TITLE	Addition of UPBO specifications to “VDSL2-NL1 and VDSL2-NL2” signal descriptions		
PROJECT	SpM-1 (new study points, in addition to SP 1-1 and 1-2)		
AUTHORS:	Rob van den Brink, Hernan Cordova, Teun van der Veen, Bas van den Heuvel – TNO.		
SOURCE:	Rob F. M. van den Brink, TNO, KPN PO Box 5050 2600 GB Delft The Netherlands	tel: +31.15.2857059 fax: +31.15.2857375 e-mail: Rob.vandenBrink@tno.nl	
STATUS	for decision, and inclusion into SpM-1		
ABSTRACT ¹	This contribution elaborates on the inclusion of Upstream Power Back-Off (UPBO) in spectral management descriptions of VDSL2 signals. The proposed description method has the advantage that it is independent from the UPBO implementation in VDSL2 modems and independent from the loop characteristics. Values for VDSL2_NL1 and VDSL2_NL2 have been elaborated for inclusion into the SpM-1 document (ETSI TR 101 830-1).

3 Literal text proposal

Figure 4: Spectral Power for "VDSL2-NL1" upstream *transmit* signals, as specified in table 1.

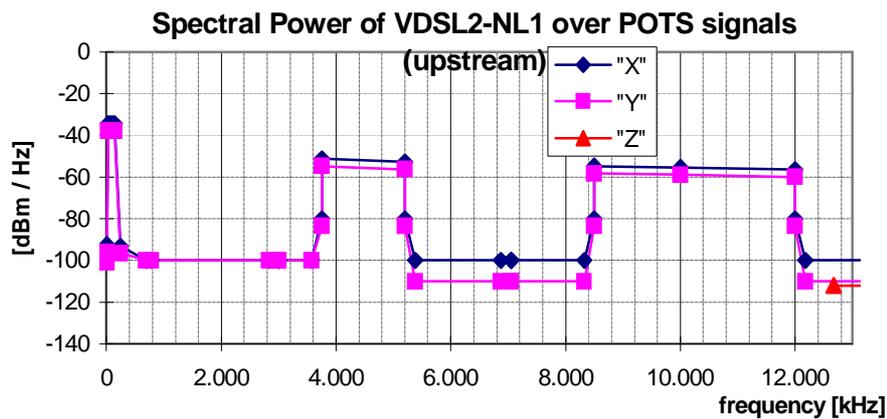
To be compliant with this signal category, the *Narrow-Band Signal Power* (NBSP) of the upstream signal *transmitted* into the NT-port of the sub loop wiring shall not exceed the limits given in Table 1,

NOTE 2: The NBSP specification of the upstream transmit signal (table 1) has been split into three overlapping limits: "X", "Y" and "Z". All three upper limits hold simultaneously. The 10 kHz bandwidth values represent the "maximum PSD values" from [1], and includes the pass band ripple. The 100 kHz bandwidth values represent the "average PSD values" in the pass band to smooth out the spectral ripple of 3,5 dB. The 1 MHz bandwidth specification is equivalent to the sliding window specification being common for ADSL

Centre frequency f	Impedance R	Signal Level P	Power bandwidth B	Spectral Power P/B	
12000 kHz	SAME AS	IN CURRENT	DESCRIPTION	-55,5 dBm/Hz	"X"
	100 Ω	-15,5 dBm	10 kHz		
	SAME AS	IN CURRENT	DESCRIPTION		
11999,999 kHz	SAME AS	IN CURRENT	DESCRIPTION	-59 dBm/Hz	"Y"
	100 Ω	-9 dBm	100 kHz		
	SAME AS	IN CURRENT	DESCRIPTION		
	SAME AS	IN CURRENT	DESCRIPTION		"Z"
EDITORIAL NOTE: Only the values highlighted in blue have been updated, to follow recent ITU changes

Figure 5: Spectral Power for "VDSL2-NL1" upstream *receive* signals,

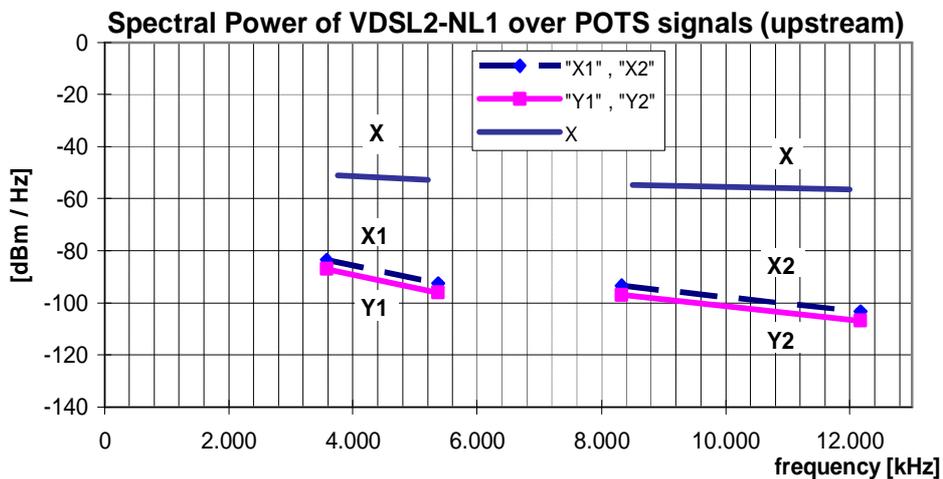
at any point of the specified frequency range. Simultaneously, the NBSP *received* from the LT-port of the sub loop wiring shall not exceed the limits given in Table 2.

NOTE 3: The NBSP specification of the upstream receive signal (table 2) has been split into four overlapping limits: "X1", "X2", "Y1" and "Y2". All these limits hold simultaneously, as explained in NOTE 2.

Frequency F	Impedance R	Signal Level P	Power bandwidth B	Spectral Power P/B	
3575 kHz	100 Ω	-43,45 dBm	10 kHz	-83,45 dBm/Hz	"X1"
...	100 Ω	interp	10 kHz	interp	
5375 kHz	100 Ω	- 52,65dBm	10 kHz	-92,65 dBm/Hz	
8325 kHz	100 Ω	-53,41 dBm	10 kHz	-93,41 dBm/Hz	"X2"
...	100 Ω	interp	10 kHz	interp	
12175 kHz	100 Ω	-63,37dBm	10 kHz	-103,37 dBm/Hz	
3575 kHz	100 Ω	-36,95 dBm	100 kHz	-86,95 dBm/Hz	"Y1"
...	100 Ω	interp	100 kHz	interp	
5375 kHz	100 Ω	-46,15dBm	100 kHz	-96,15 dBm/Hz	
8325 kHz	100 Ω	-46,91dBm	100 kHz	-96,91dBm/Hz	"Y2"
...	100 Ω	interp	100 kHz	interp	
12175 kHz	100 Ω	-56,87dBm	100 kHz	-106,87dBm/Hz
